Site Plan for Subdivision Prepared for: Fountain Hills Plaza, LLC

ADMINISTRATIVE AMENDMENT
 File # 07-10066 Project # 1003445
 Lot line adjustment to match plat
 Approved by: [Signature] DATE: 9/14/07

Project Number: 1003445
 Application Number: 07DRB-70063

Site Plan For Subdivision
A1

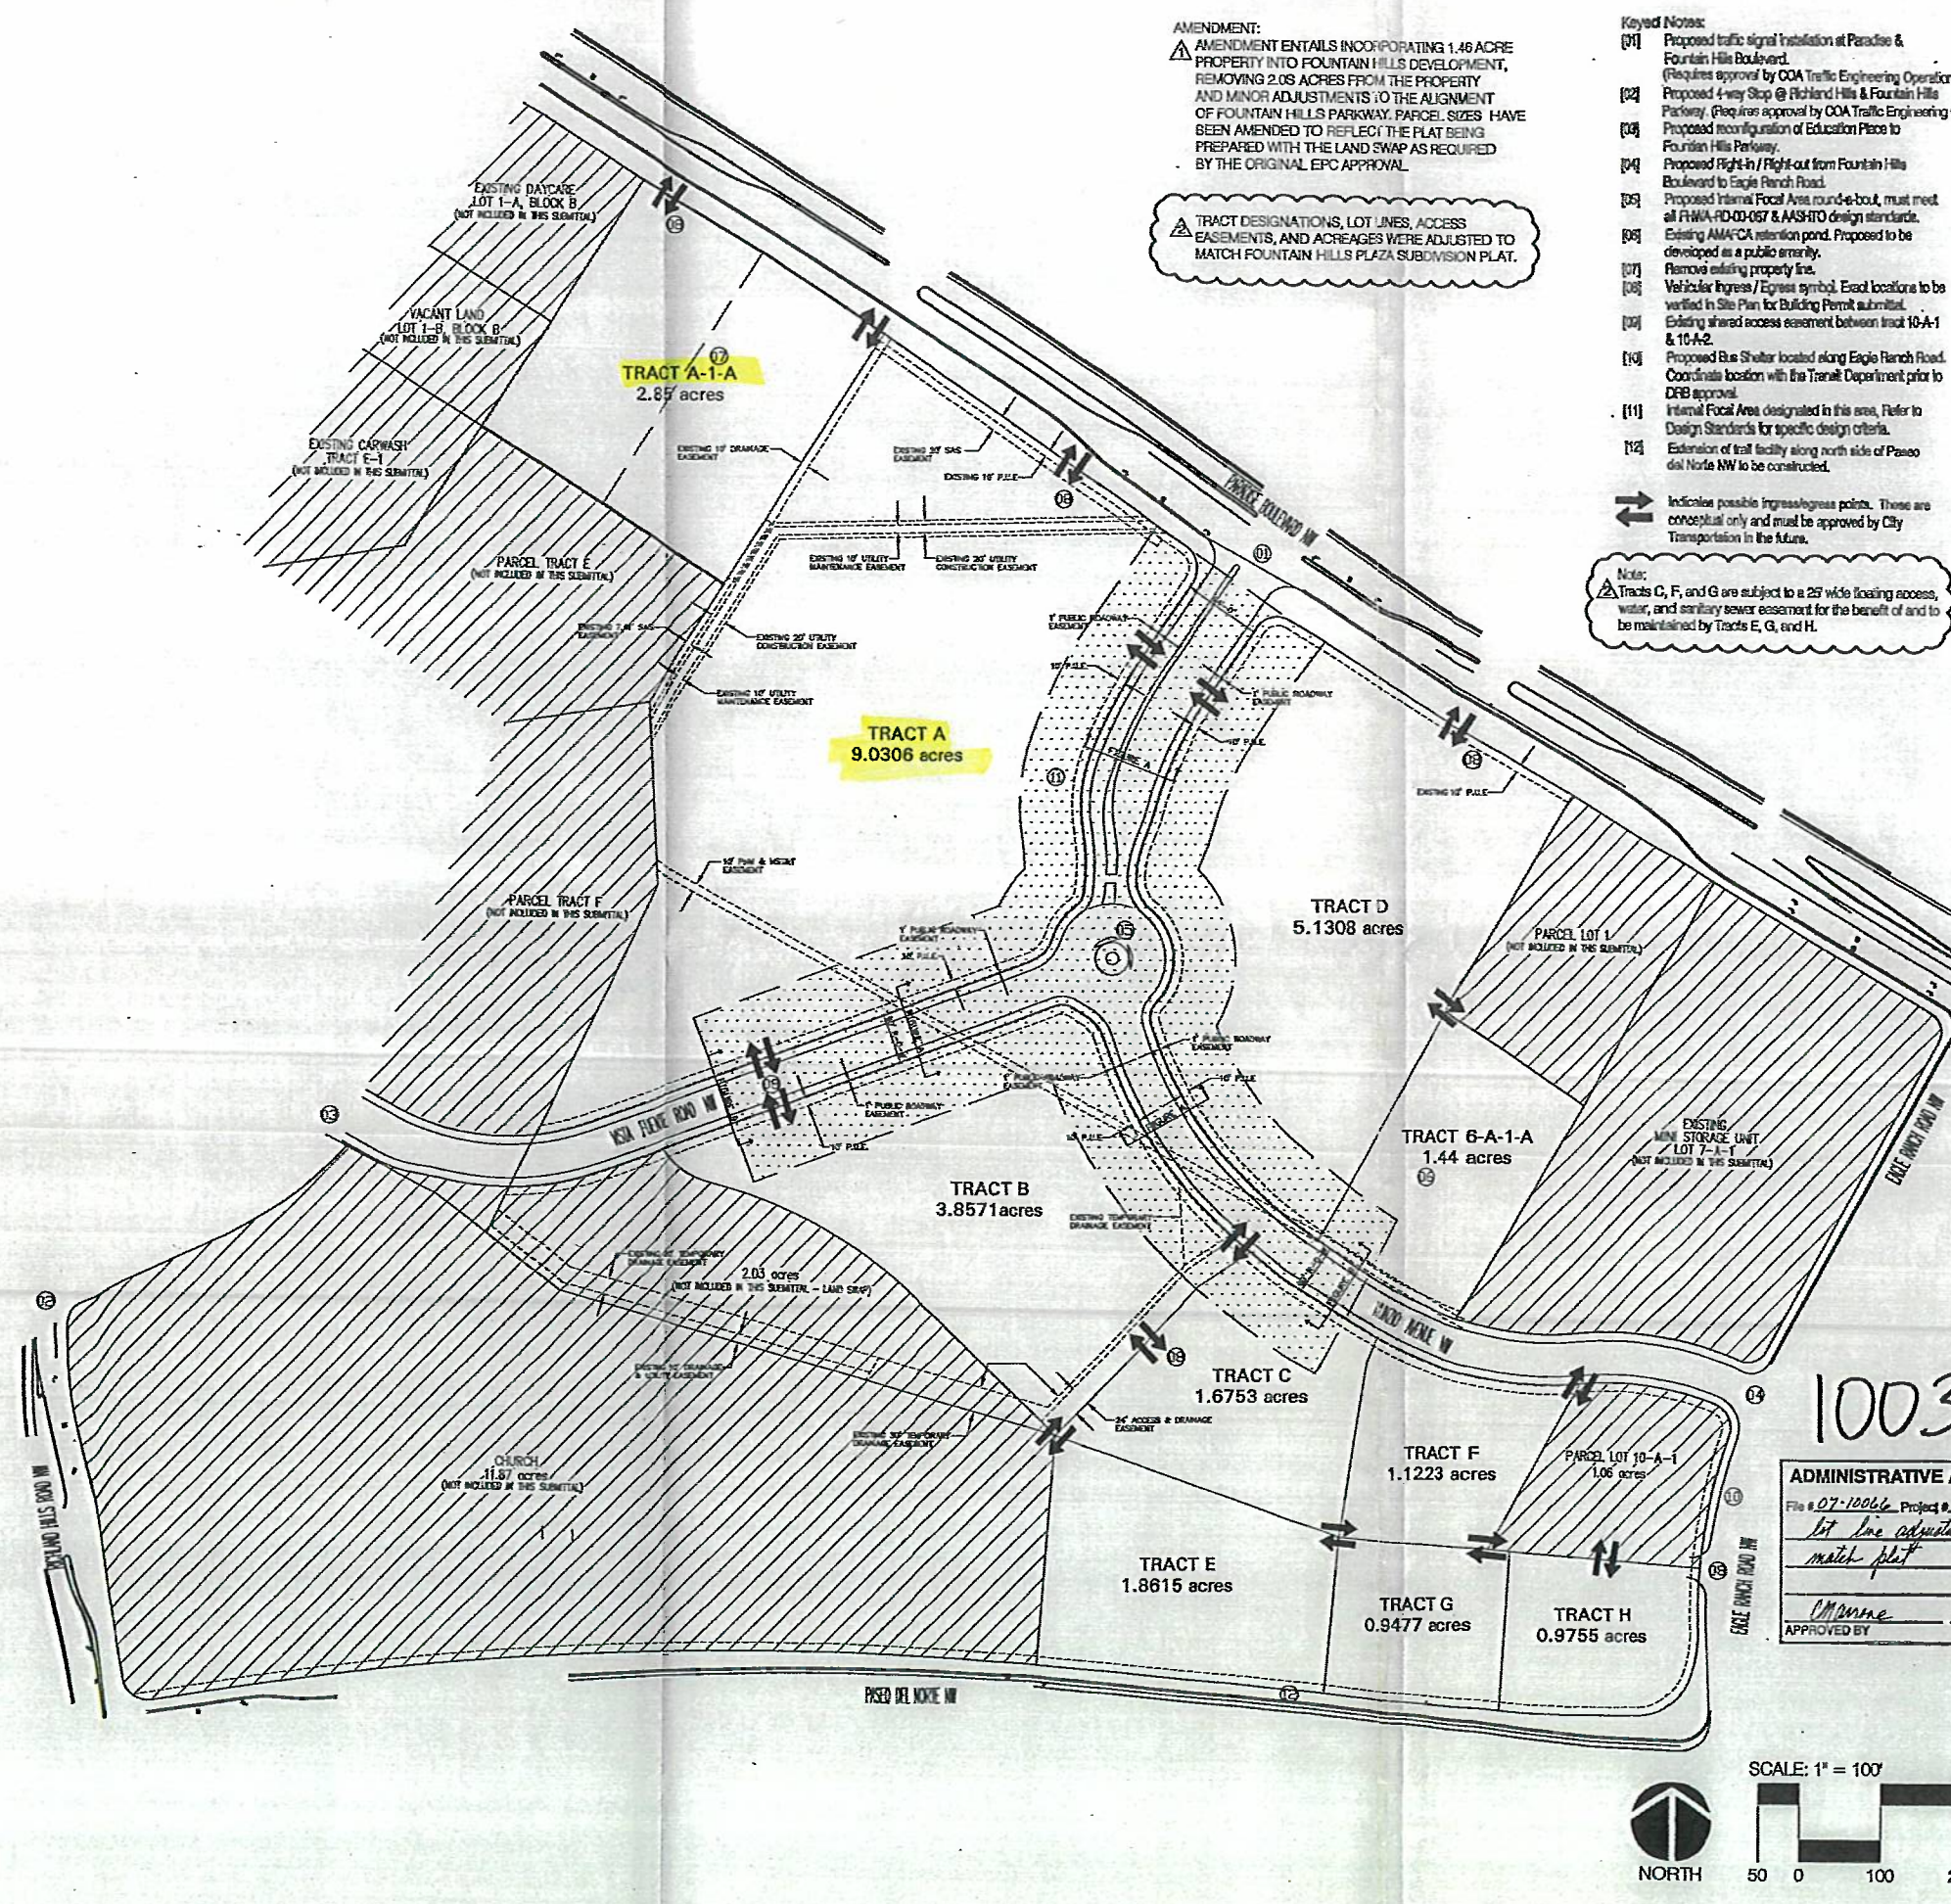
AMENDMENT:
 AMENDMENT ENTAILS INCORPORATING 1.46 ACRE PROPERTY INTO FOUNTAIN HILLS DEVELOPMENT, REMOVING 2.08 ACRES FROM THE PROPERTY AND MINOR ADJUSTMENTS TO THE ALIGNMENT OF FOUNTAIN HILLS PARKWAY. PARCEL SIZES HAVE BEEN AMENDED TO REFLECT THE PLAT BEING PREPARED WITH THE LAND SWAP AS REQUIRED BY THE ORIGINAL EPC APPROVAL.

TRACT DESIGNATIONS, LOT LINES, ACCESS EASEMENTS, AND ACREAGES WERE ADJUSTED TO MATCH FOUNTAIN HILLS PLAZA SUBDIVISION PLAT.
